TECHNICAL ADVISORY COMMITTEE REPORT

FILE NUMBER: 24-DP-24

SUBJECT: Preliminary Site Plan review for an approximately 2,490 SF Warehouse Building

WAREHOUSE METAL BUILDING
 6013 RODMAN STREET
 HOLLYWOOD, FL 33023

1 PROPOSED SOUTH ELEVATION
 SCALE: 1/4" = 1'-0"

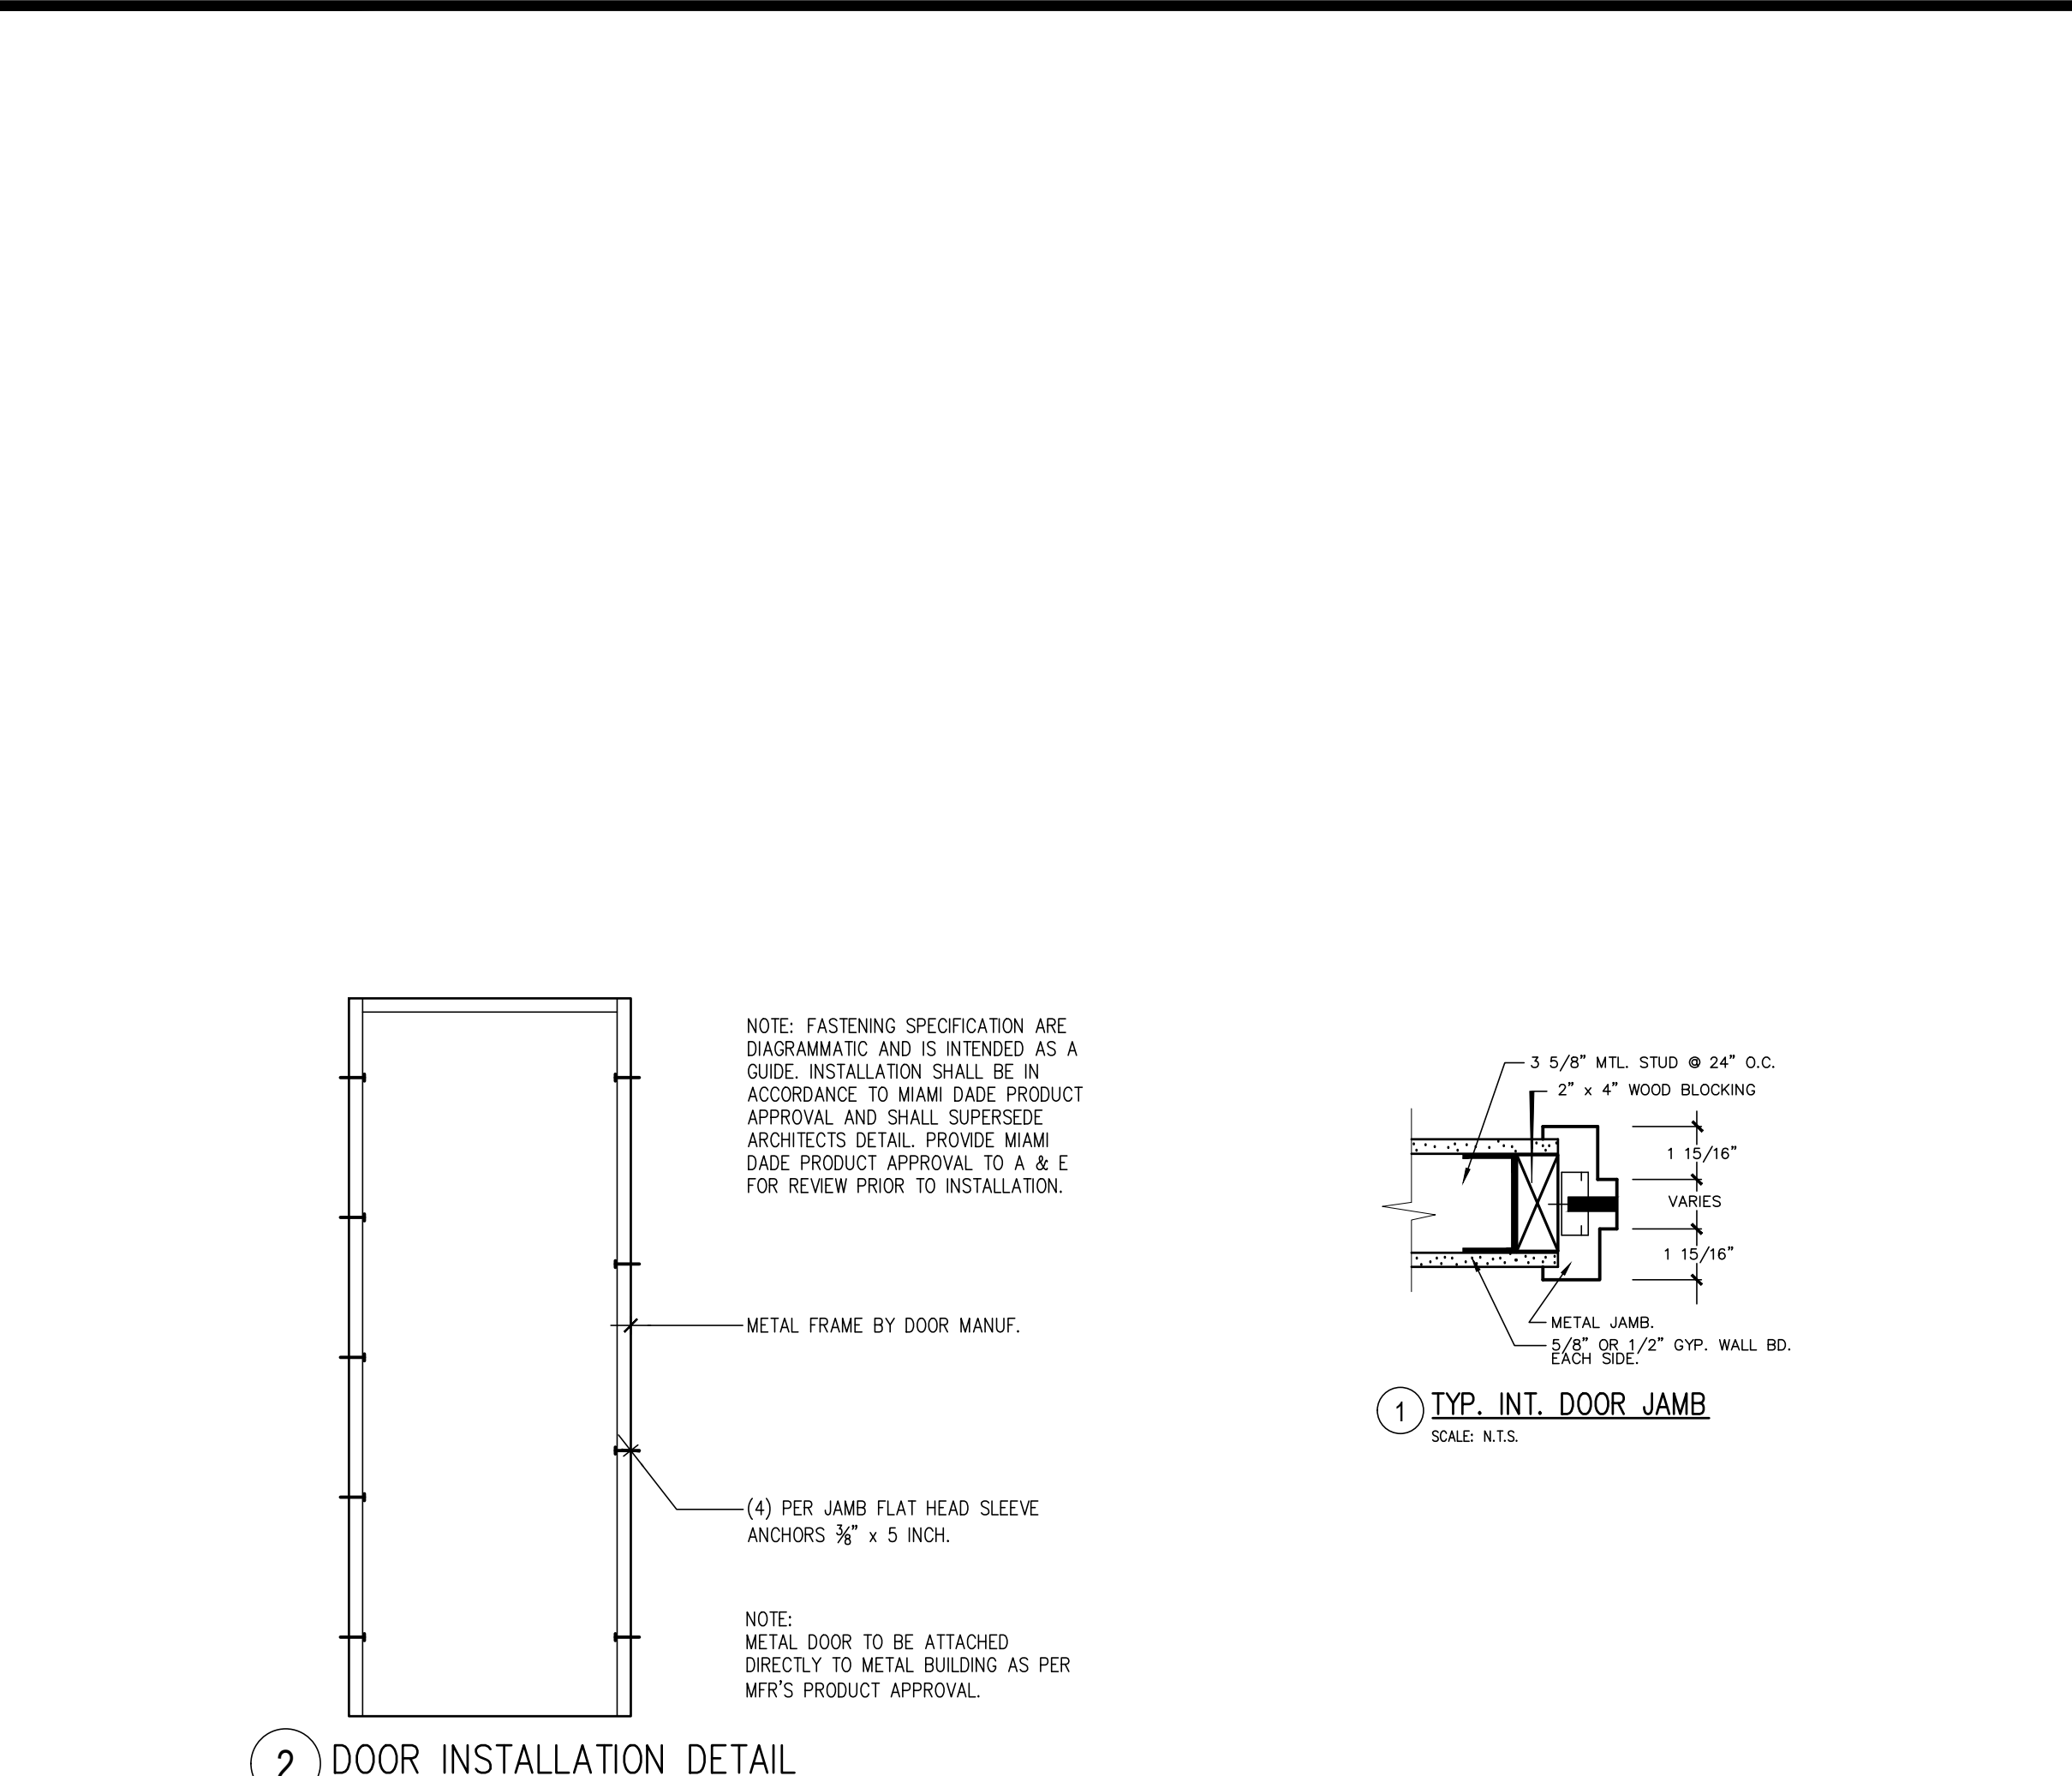
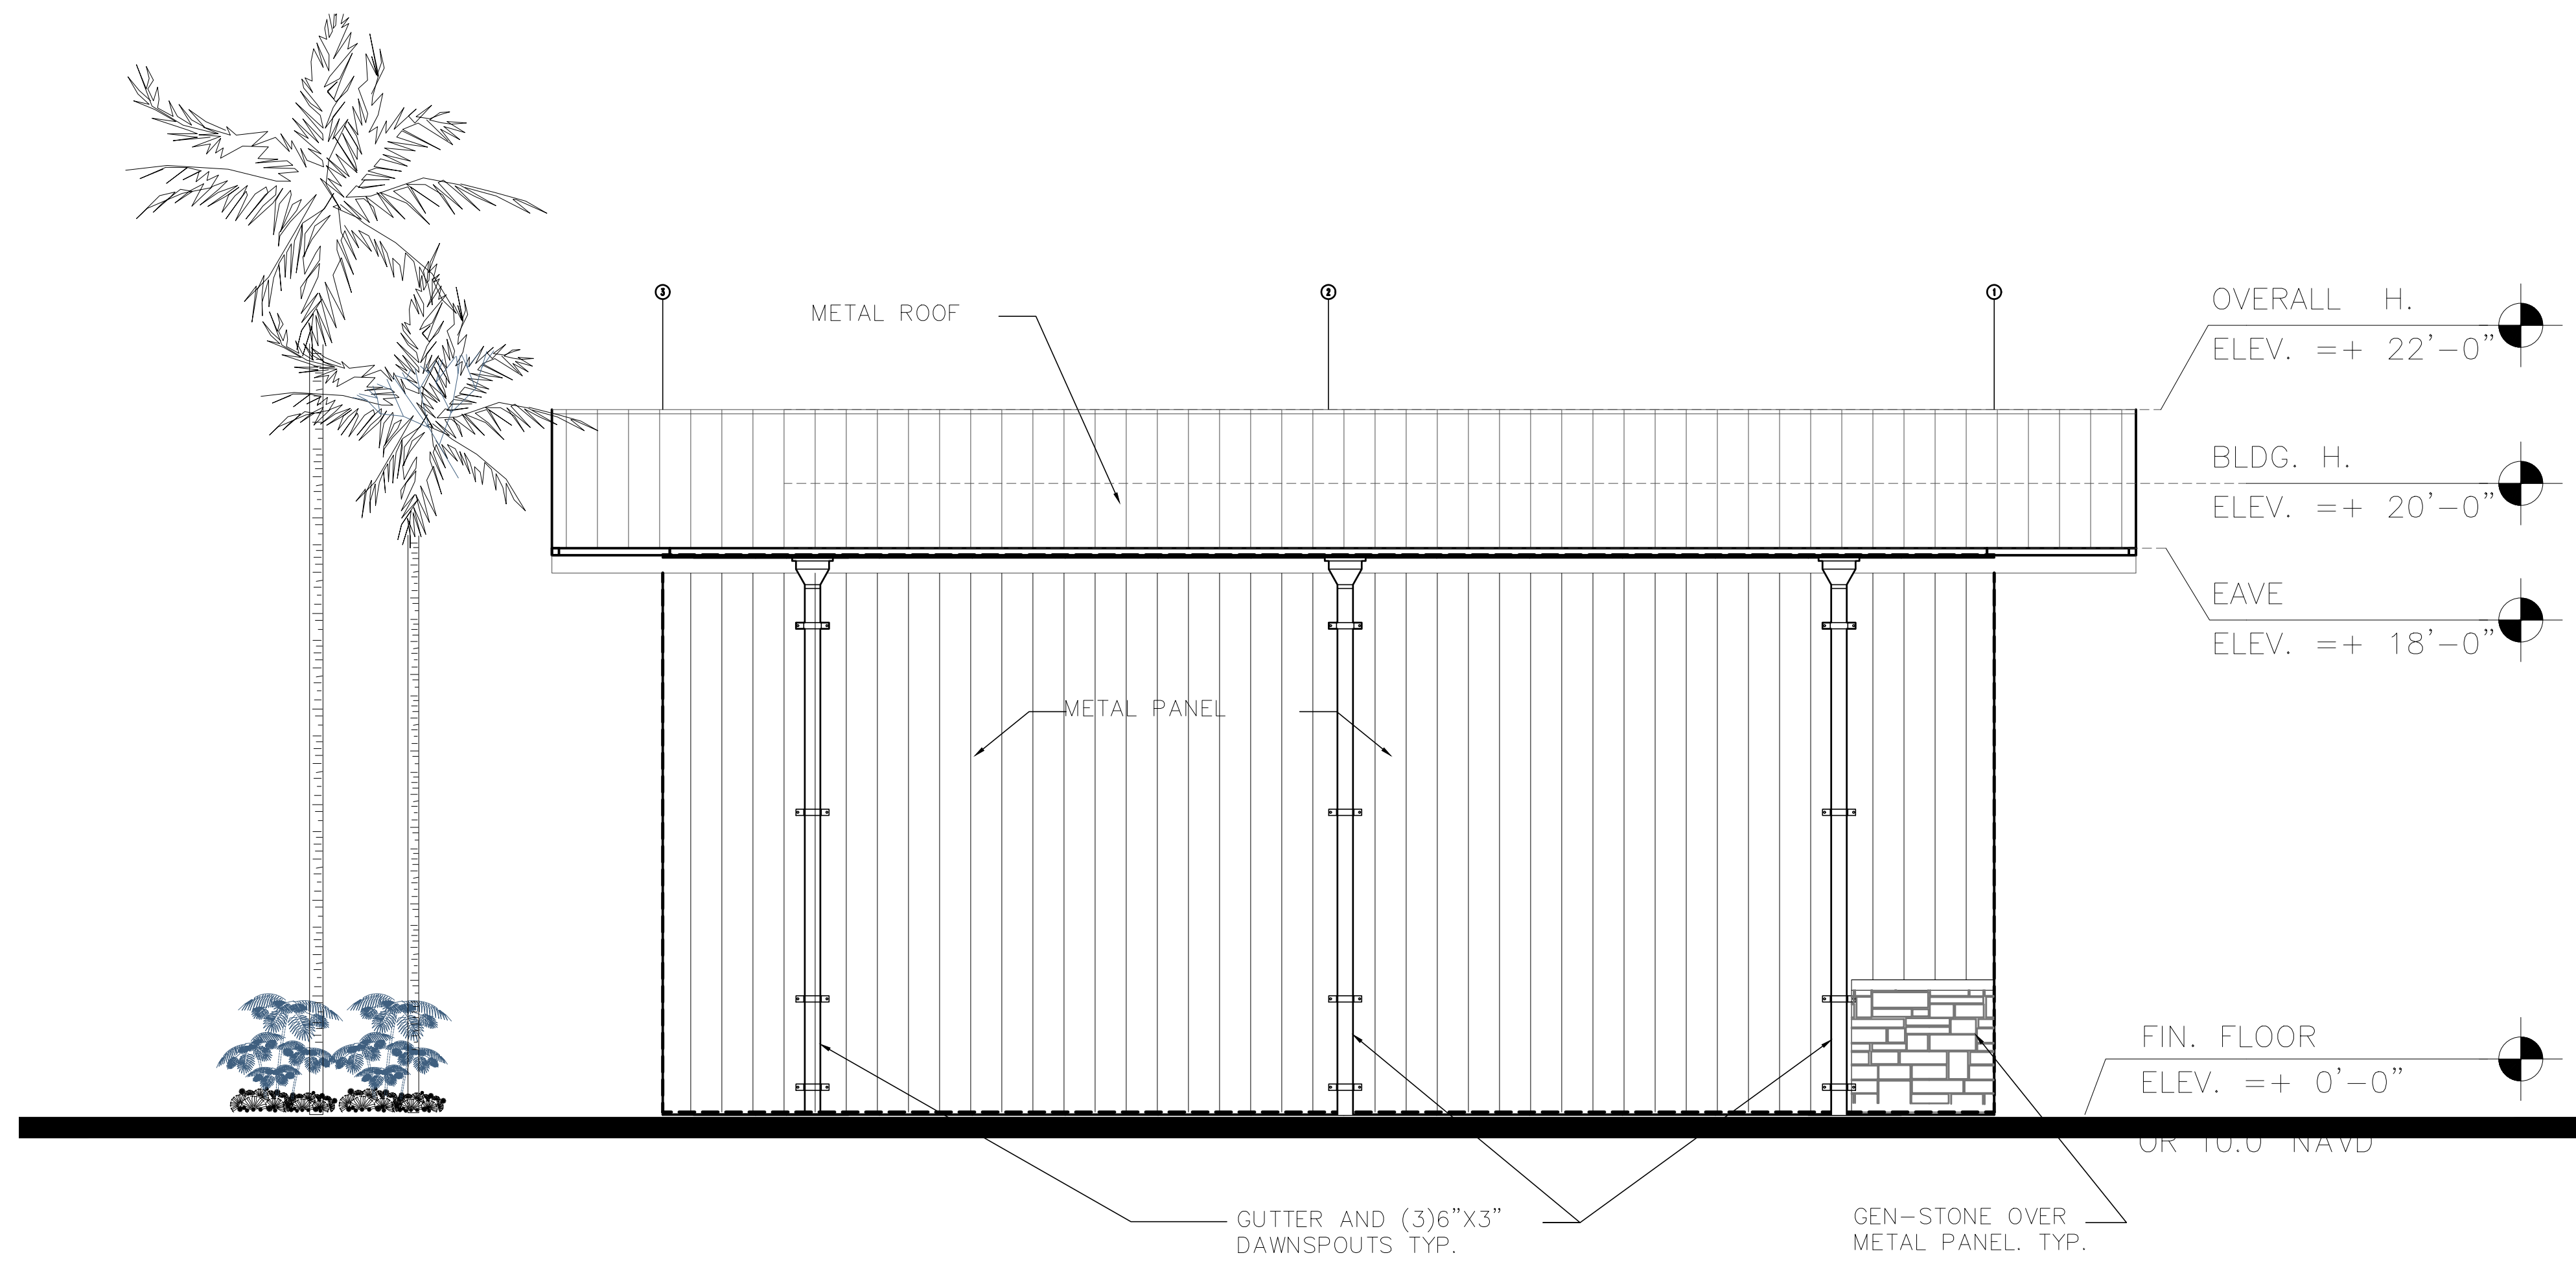
- 1. Provide material legend elevations. **PLEASE SEE MATERIAL SHOWED ON ELEVATIONS, A-2.0 AND A-2.1**

19. Add dimensions to the openings on the elevations on Sheet A-2.0 and on the site plan SP-1. **PLEASE SEE THE REVISED SITE PLAN SP-1 AND SHEETS A-2.0.**

20. Label the height of the entrances, exits, and doorways on the elevations on A-2.0. **PLEASE SEE REVISED SHEET A-2.0.**
21. Please clearly call out in the plans for swales to be restored along Rodman Street. This should be restored with grass to the City of Hollywood Typical Swale Grading Detail and Turf Restoration Detail, please include details in plan set. **A NOTE WAS ADDED TO THE PLAN C2.**
